***Development Special Use Permit #2018-0007
Transportation Management Plan SUP#2018-0062
1200 N. Fayette Street – Braddock Gateway Phase III***

Application	General Data	
Project Name: Braddock Gateway Phase III	PC Hearing:	December 6, 2018
	CC Hearing:	December 15, 2018
	If approved, DSUP Expiration:	December 15, 2021
	Plan Acreage:	2.58 acres (112,375 SF)
Location: 1200 N. Fayette Street	Zone:	Coordinated Development District #15/CDD #15
	Proposed Use:	Mixed-Use (Residential/Retail)
	Dwelling Units:	370
	Gross Floor Area:	336,358 SF (residential & retail) 138,820 SF (parking garage)
Applicant: CP VI Braddock Station LLC	Small Area Plan:	Braddock Metro Neighborhood Plan
	Historic District:	N/A
	Green Building:	Compliance with City's Green Building Policy

Staff Recommendation: APPROVAL WITH CONDITIONS
Staff Reviewers: Robert Kerns, AICP, Chief of Development; robert.kerns@alexandriava.gov Gary Wagner, PLA, Principal Planner; gary.wagner@alexandriava.gov Stephanie Free, PLA, LEED GA, Urban Planner III; stephanie.free@alexandriava.gov
PLANNING COMMISSION ACTION DECEMBER 6, 2018: On a motion by Commission Wasowski, seconded by Commissioner McMahon, the Planning Commission recommende

Figure 4 – Vision Clearance Modification

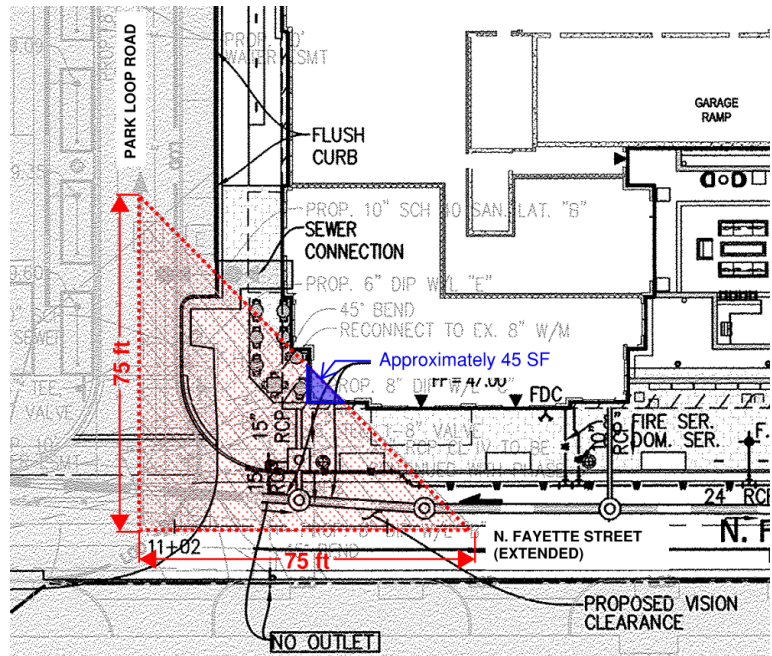
Per Section 7-801, buildings with corner frontage or on corner lots shall have no structure or other obstructions “within the area enclosed by the centerline of the intersecting streets and a line joining points on such centerlines at distances from their intersections.” A setback of 75 feet (shown in red, Figure 4) is required at the corner of N. Fayette Street and the future park loop road. The applicant requests a modification of this setback for approximately 45 square feet (shown in blue, Figure 4) of building area that occurs within this vision clearance.

1. This modification is desirable for the building to maintain the urban street wall along the extension of N. Fayette Street. Further, this corner is the location of the retail space which fronts the community park. Maximizing this retail space aids in further activation of the corner and community park.
2. The approximately 45 square foot building area which falls within the required vision clearance is limited to a height of 27 feet measured from the average

finished grade. At this point, the building steps back, creating “shoulders” along N. Fayette Street as required by the BMNP.

3. The requested modification will have minimal impact to the area and no detrimental effect on property, as the adjacent streets are designed to handle low-speed traffic in a to-be highly walkable portion of the City.
